# **TECHNICAL BULLETIN EN-34**

**ENGINE MODEL:** J08

**UD1800HD ~ UD3300** CHASSIS MODEL:

#### 2006 JOB INTAKE PIPE GASKET DESIGN CHANGE

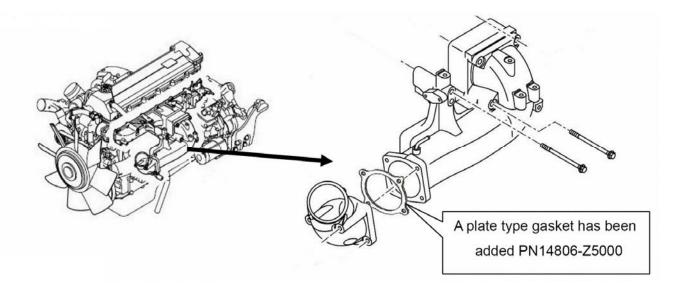
Engines produced during June, 2005 and after, will utilize a plate type gasket (PN 14806-Z5000) on the intake pipe as shown below. The application of liquid gasket compound is no longer used.
